**SUNDRY NOTICES AND REPORTS ON WELLS**  
*Do not use this form for proposals to drill or to re-enter an abandoned well. Use Form 3160-3 (APD) for such proposals.*

**Central Bisti Unit 97**

## PLUG AND ABANDONMENT PROCEDURE

CONDITIONS OF APPROVAL

## Proposed P&A

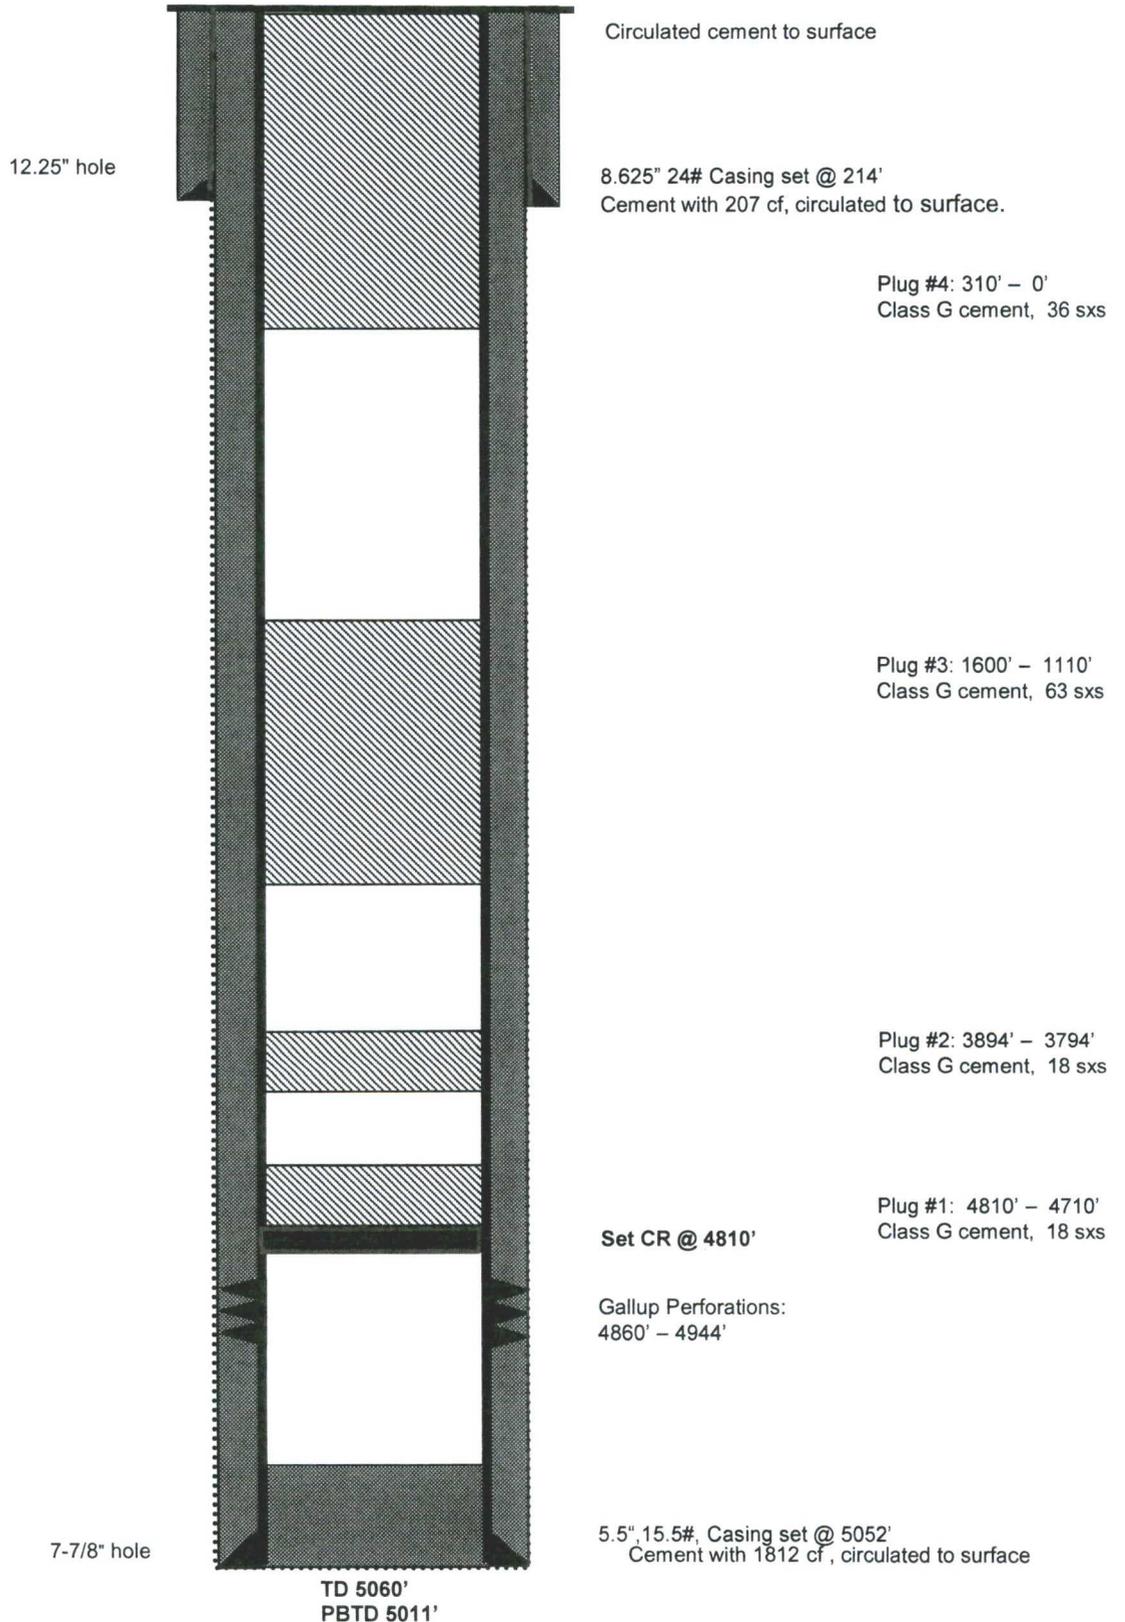
- a) Set plug #1 (4810 – 4650) ft. to cover the Gallup top. BLM picks top of Gallup at 4700 ft.
- b) Set plug #3 (2010 - 855) ft. to cover the Mesaverde, PC, and Fruitland tops. BLM picks top of Mesaverde at 1960 ft. BLM picks top of Fruitland at 905 ft.
